Master Plan Report (Volume 2)

**Upper Little River Watershed
Drainage and Stormwater
Management Master Plan, Class
Environmental Assessment,
Windsor and Tecumseh, Ontario**

April 2023

Figure - 14

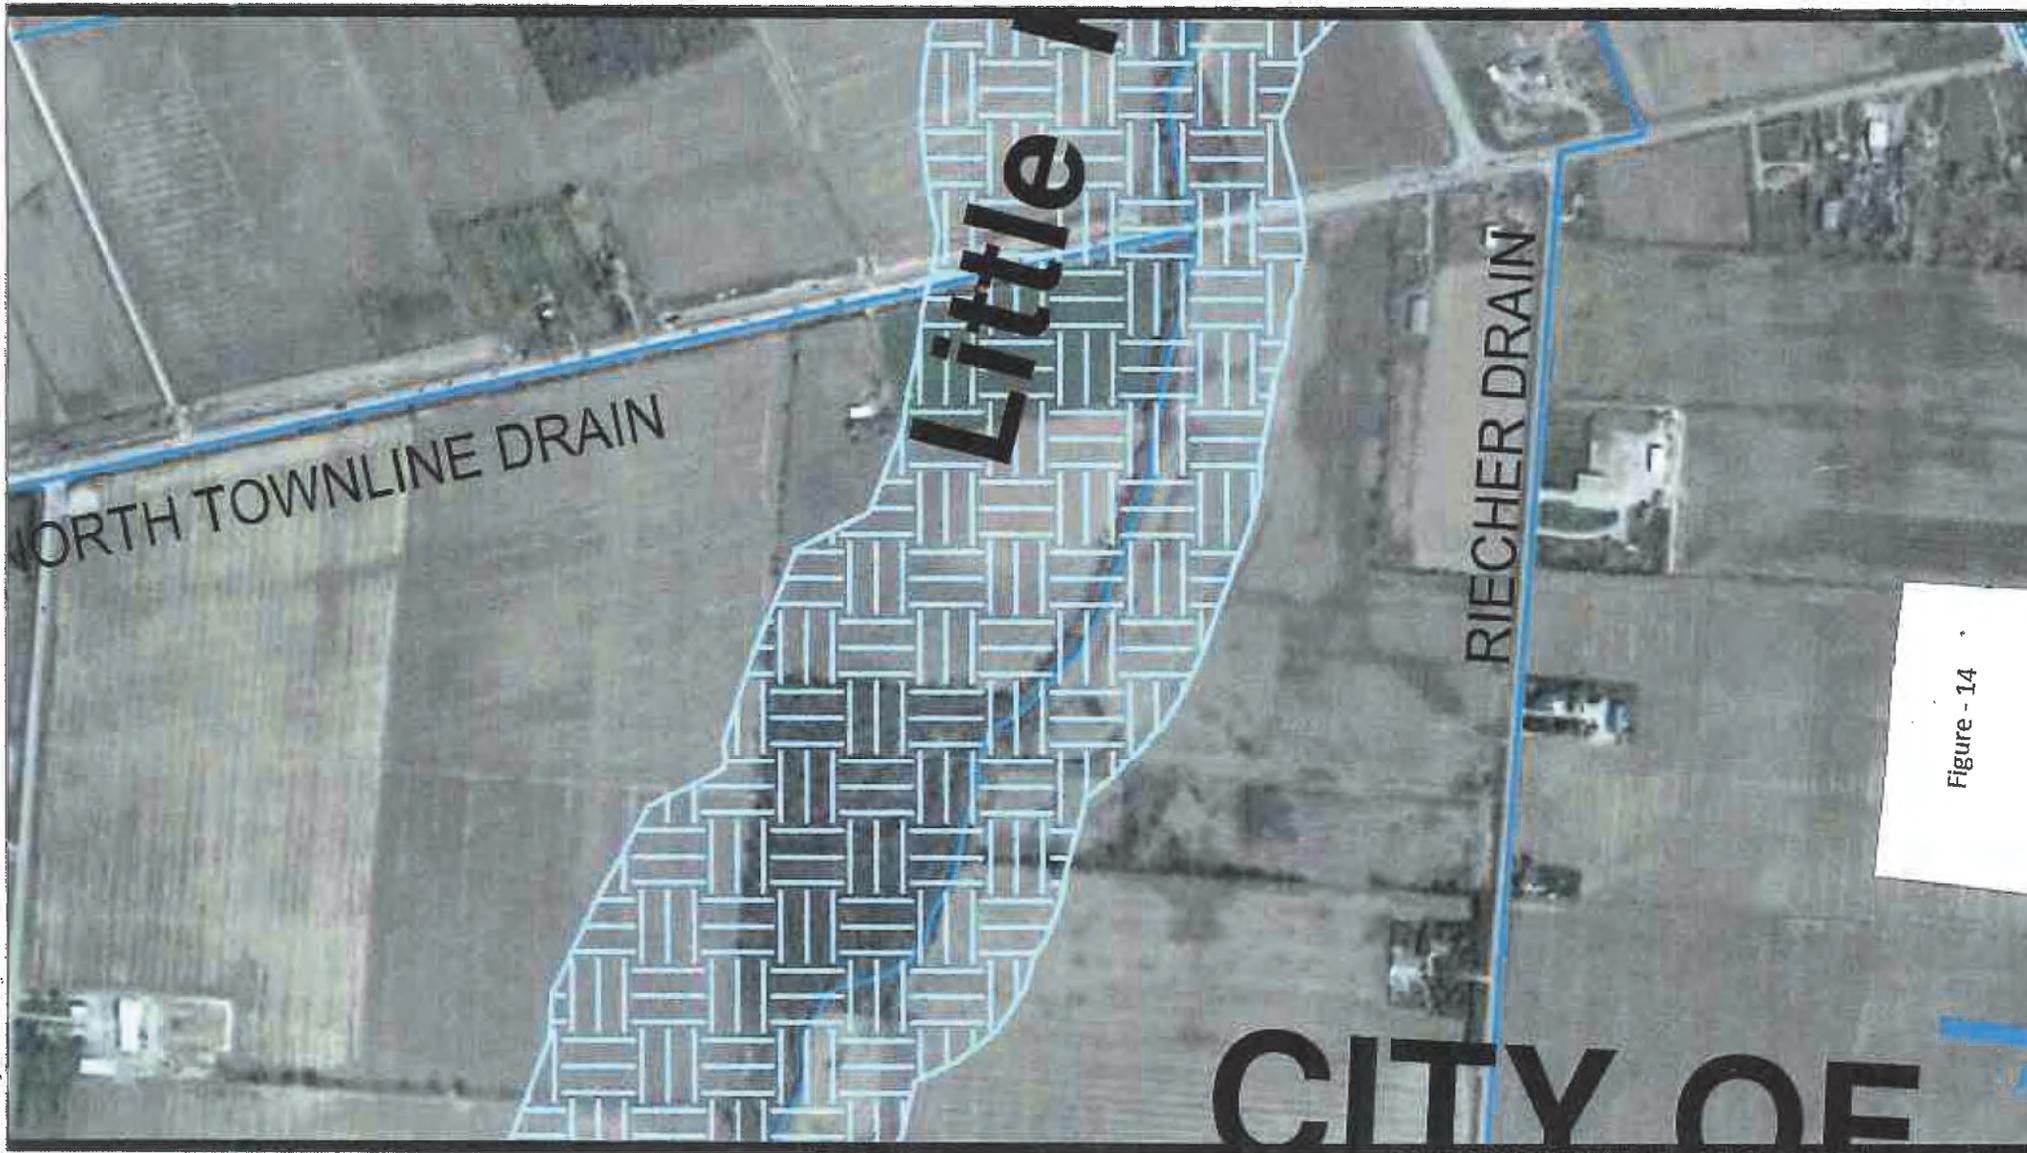
The study report not does reference any of the above, as well as a study for the Hospital Lands under County Road 42 Secondary Plan, which is underway and the reserve corridor size clearly does impact said lands and does restrict my land use available for development and does place a large portion of our lands in limbo as seen on (Figure - 14).

* Mr. Balazs showed them an aerial type picture (Figure- 13(-zoom view of Figure 2)and Figure-3) per larger map, part of Lauzon Parkway) from the discussions of 2012 and the **impact of 325 m** corridor and the 225 portion over his lands and the other side would be 100 m (Figure -14 a zoomed view of page 187 report)

Figure - 10

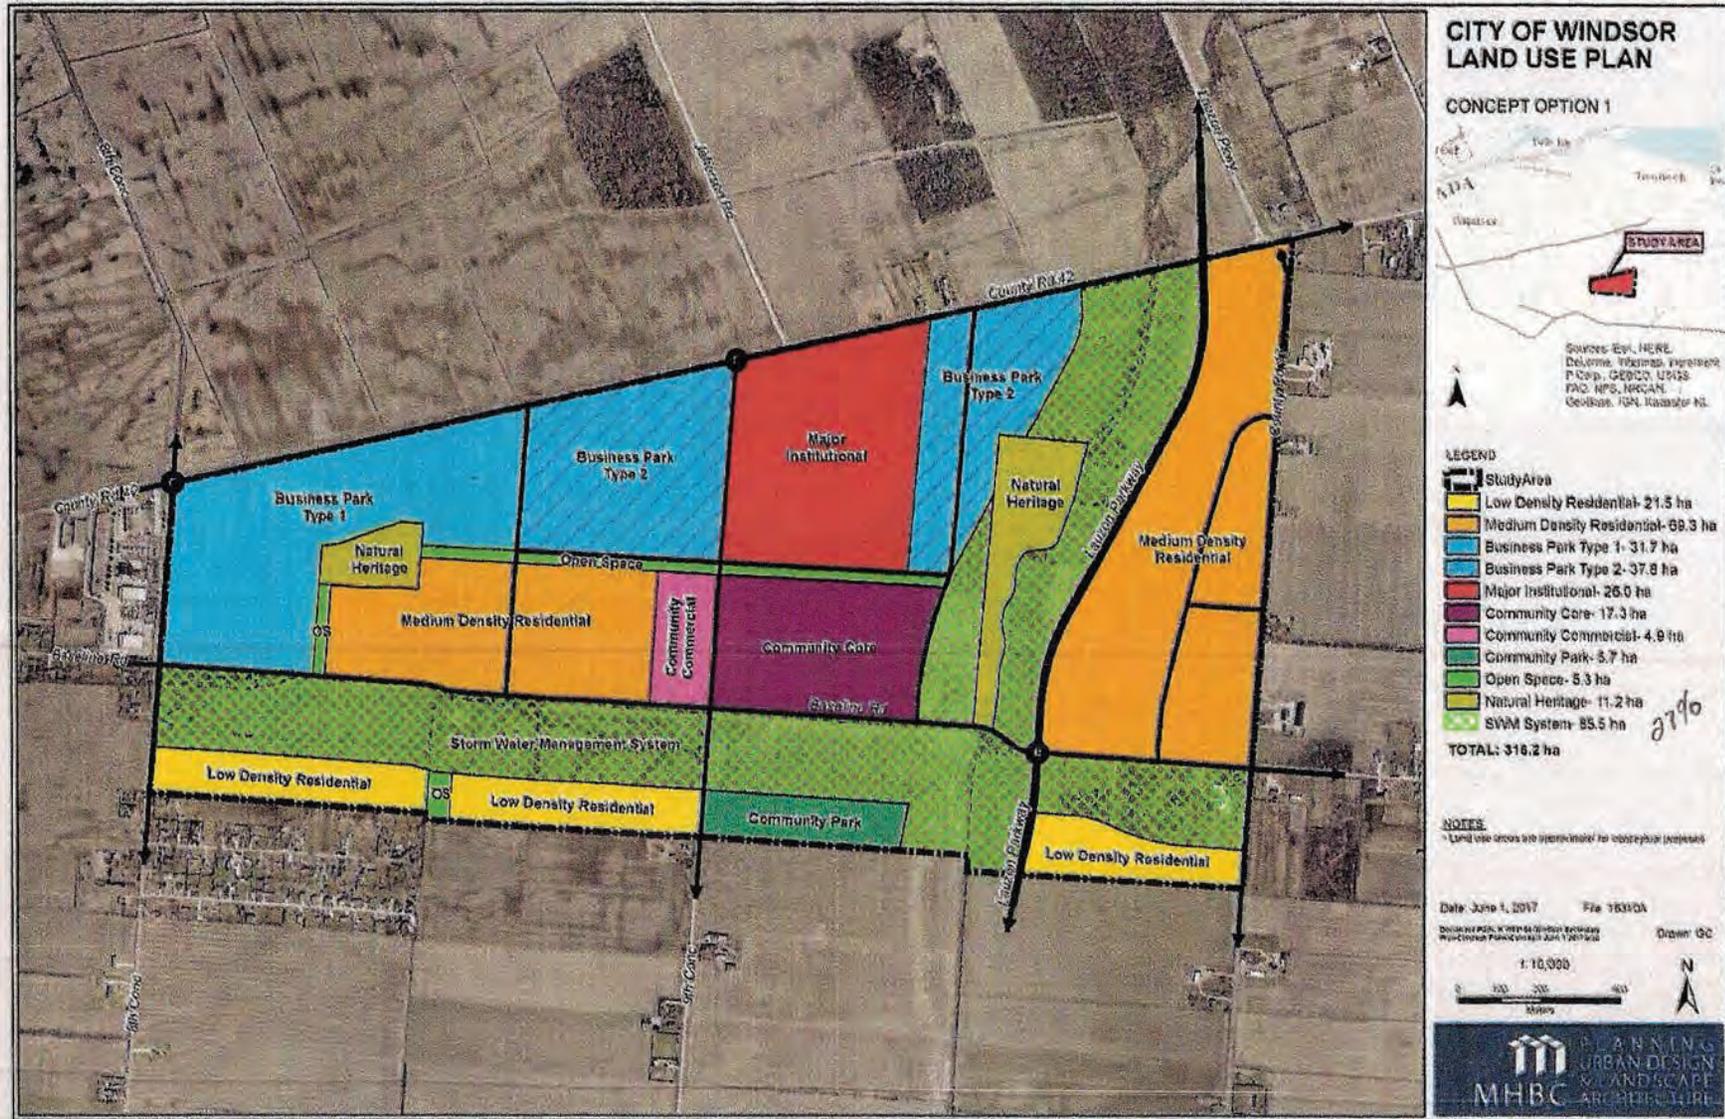
* review -of Open House held on September 7th, 2106 -location of hospital climate change (which has been a factor for more then, 10 years), revised word of Park/Open Space to be corrected to SWM System, reflecting larger corridor size to increase corridor size 250 m of river from County Road 42 to Baseline and tributary size of 150 m as represented by site plan for said Secondary Plan. (reference Figure- 2 and Option 1 Figure- 10)

PROPERTY LINES
Figure - 11

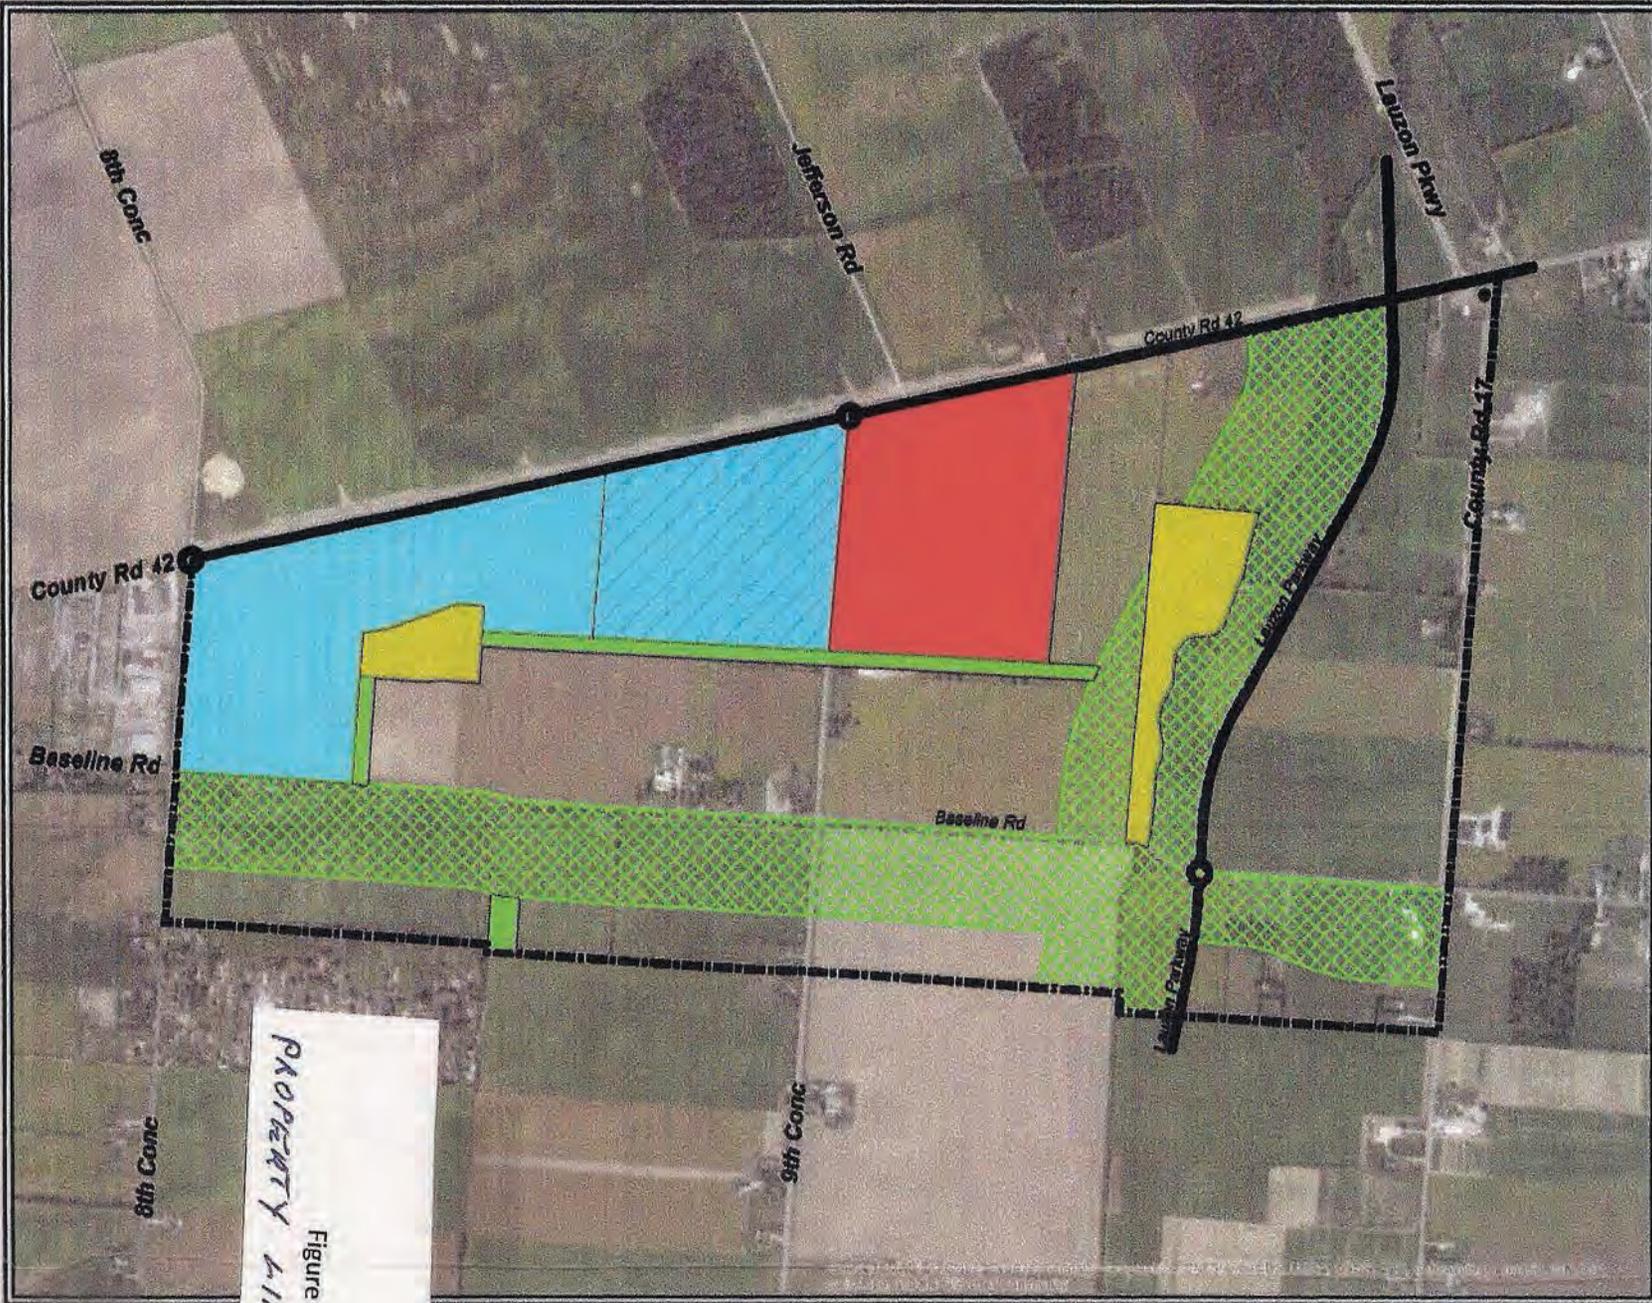
--July 5, 2017- Public Consultation Session County Road 42- Secondary Plan that did include some requested changes or additions(Figure- 11) property lines and SWM system) and some changes in Preferred Development Plan (as seen on Figure -12).
